Addendum 151 – UN Regulation No. 152

Revision 1 - Amendment 3

02 series of amendments – Date of entry into force: 30 September 2021

Uniform provisions concerning the approval of motor vehicles with regard to the Advanced Emergency Braking System (AEBS) for M₁ and N₁ vehicles

Annex 2, amend to read (addition of a letter "B" in the marking and its reference in the text):

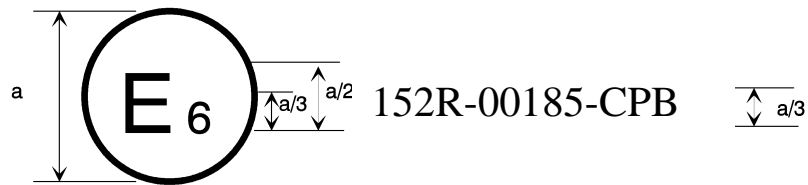
The above approval mark affixed to a vehicle shows that the vehicle type concerned has been approved in Belgium (E 6) with regard to the Advanced Emergency Braking Systems (AEBS) pursuant to UN Regulation No. 152 (marked with C for Car to Car, P for Car to Pedestrian, B for Car to Bicycle). The first two digits of the approval number indicate that the approval was granted in accordance with the requirements of UN Regulation No. 152 in its original form."
